Santa Cruz Downtown Plan Expansion Final Subsequent EIR

April 2025
SCH #: 2022090276

Kimley-Horn & Associates

Baseline Scenario (Existing Zoning and General Plan)

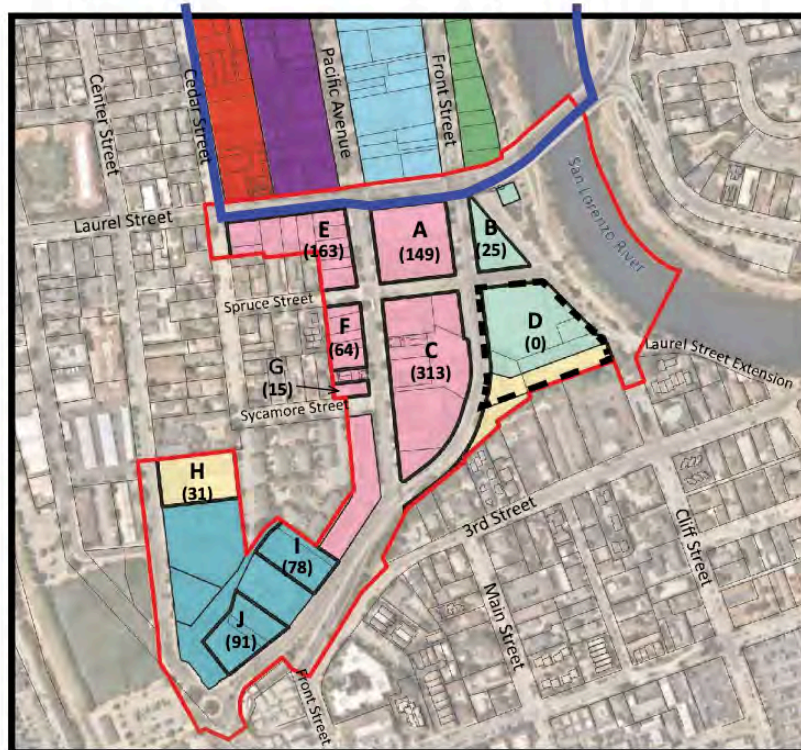
This is forecasting in bad faith and the EIR's projections *must redo their analysis (traffic, environmental etc.) for scenarios wherein there's a 75% or even 100% density bonus applied. "It probably won't happen" doesn't suffice as mitigation here, because it still can happen. Can you show the effects, empirically, that would result from your proposed upzoning PLUS developers taking advantage of a 100% density bonus on top of that? Where in this EIR are there calculations from a traffic, congestion, emissions, water use and biological (flora and fauna) standpoint? Please provide.*

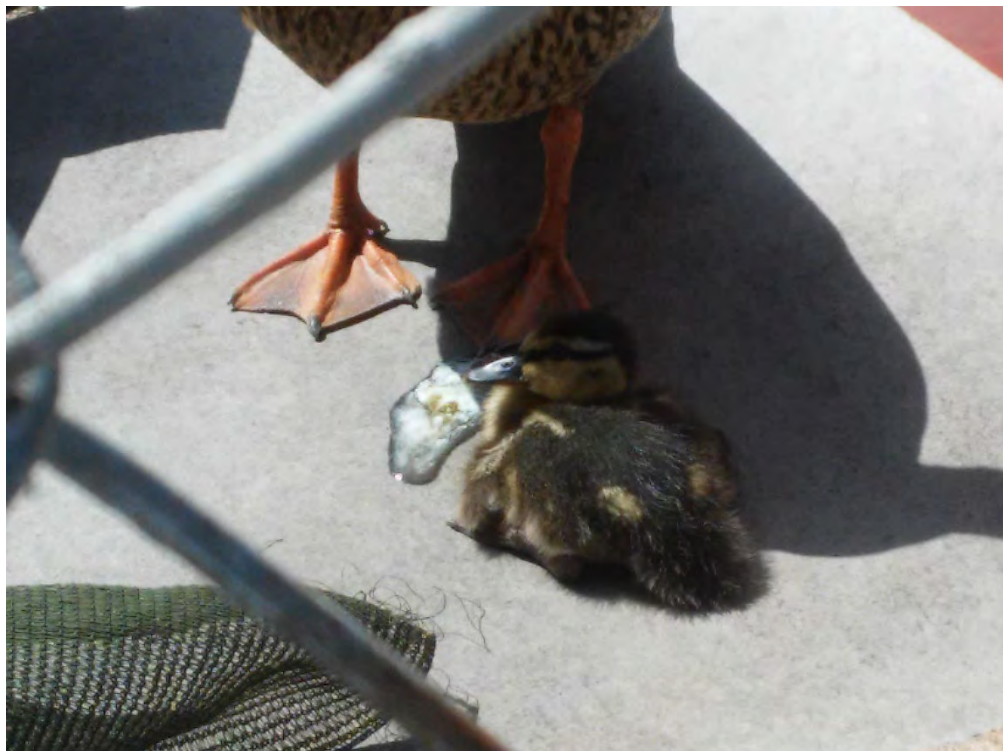
GP63-2
